RESPONSE TO REQUEST FOR ADDITIONAL INFORMATION

US-APWR Design Certification

Docket No. 52-021

RAI NO.: NO. 1044-7140 REVISION 3
SRP SECTION: 03.08.04 – Other Seismic Category I Structures
APPLICATION SECTION: 3.8.4
DATE OF RAI ISSUE: 07/08/2013

Figure 1 Building Roof Corners

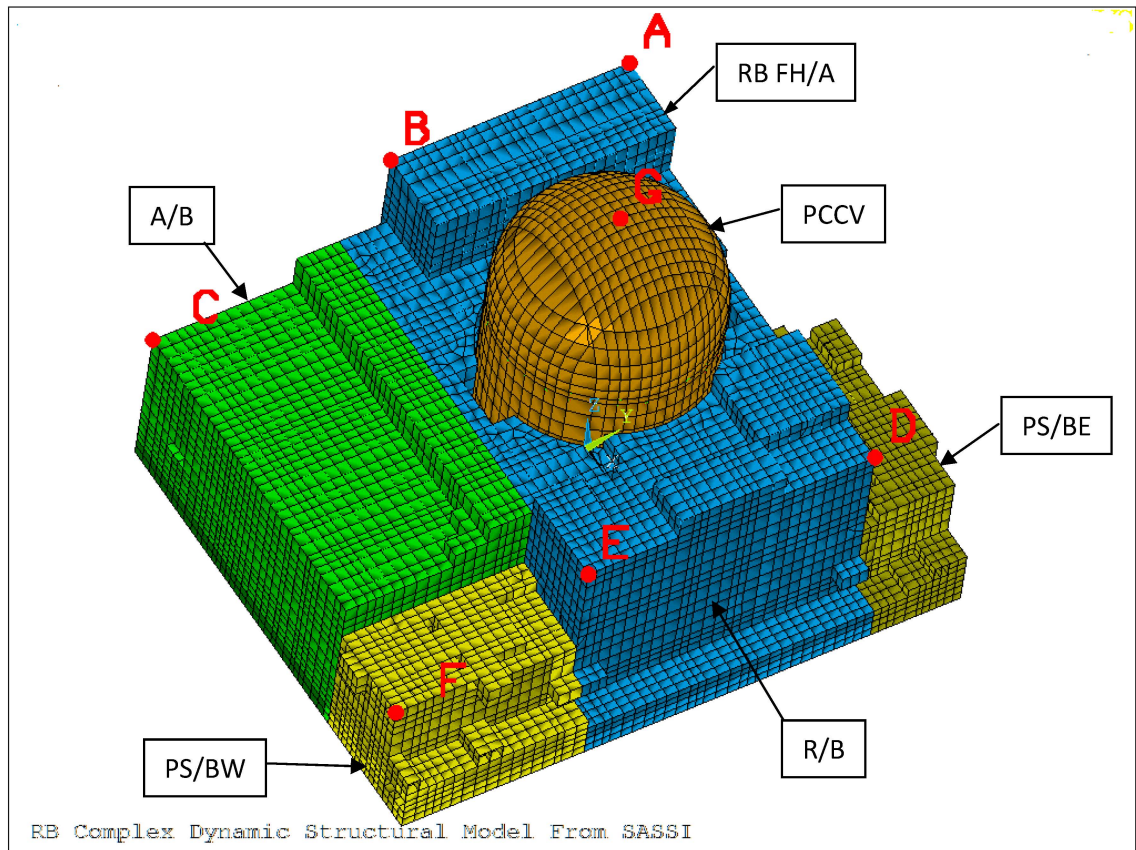
The applicant is requested to provide a table which lists the results obtained from the ANSYS analysis including the displacements at the four corners of the top of the R/B complex and the top-center of the prestressed concrete containment vessel (PCCV) dome in the x, y, and z directions. Also, the table should list the maximum forces (axial, shear, and torsion) and moments at the four sections listed in Subsection 3.8.4.4.1.1, "Structural Design of Structural Elements."

The requested ACS-SASSI and ANSYS analyses x, y, and z seismic displacements at the top corners of the respective R/B Complex structures and top-center of the PCCV dome are presented in Table 1 and the locations are shown graphically in Figure 1. The three translational displacements Ux, Uy, and Uz Displacements are provided at the following locations:

1. the four corners at the top of the R/B (see Figure 1, points A, B, D and E)
2. the North West corner at the top of the Auxiliary Building (point C)
3. the South West corner at the top of the West Power Source Building (point F), and
4. Apex of the PCCV (point G).

Figure 3: R/B Complex, Seismic Design Flow Chart

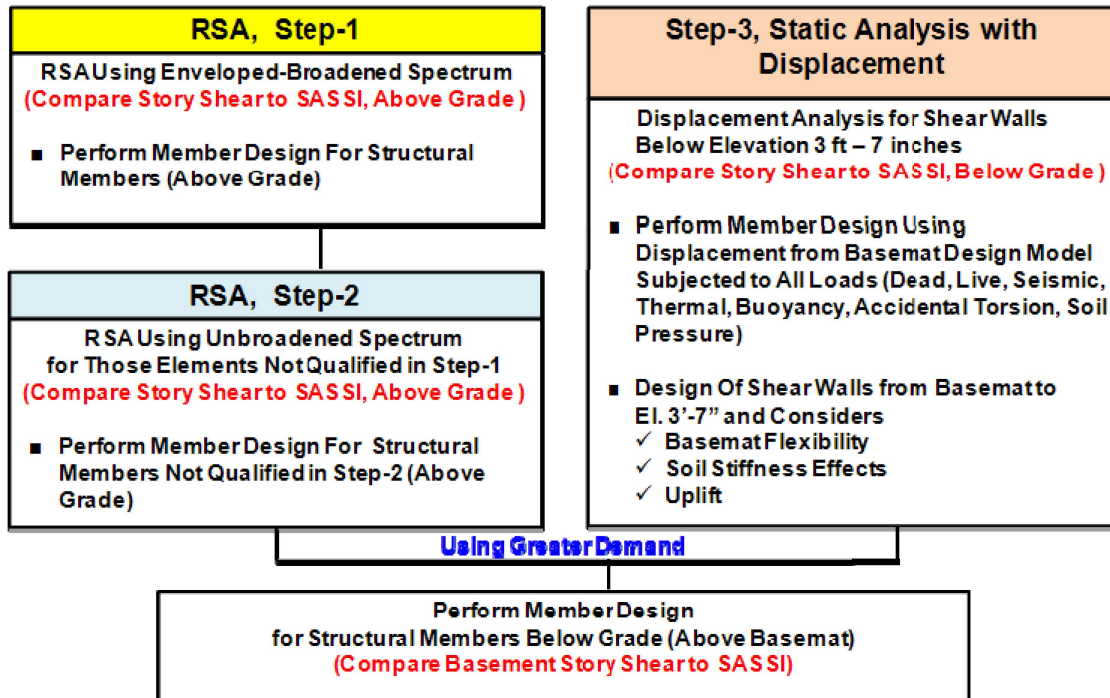
3.8 Audit - Containment Item 8. MHI to provide technical basis for not considering the rocking effects in the response spectra analysis for the design of the R/B Complex.

A flow chart of the design methodology used for the design evaluation of shear walls is provided as Figure 3. This section describes the analysis results from Step-1 using Enveloped/Broadened Response Spectra as input to the RSA analysis.

Figure 3 identifies the three step design approach for the R/B Complex with considering a difference in the design for the R/B Complex above and below elevation 3'-7". The RSA approach always envelopes the story shears from ACS-SASSI above elevation 3'-7". However, basemat flexibility and the affects of rocking are included in the design of the shear walls below elevation 3'-7".

Figure 3 Step 3 was performed separately and concentrated on the structure from elevation 3'-7" down to the basemat which represents the embedded part of the structure. The effects of displacement in the walls below Elevation 3'-7" were calculated using input from the basemat model which is described in the response to RAI 1045-7141 Question 03.08.05-51. The basemat model did include the applied seismic loads obtained from the ACS-SASSI nodal accelerations at the time steps at which the maximum base and overturning moment occur.
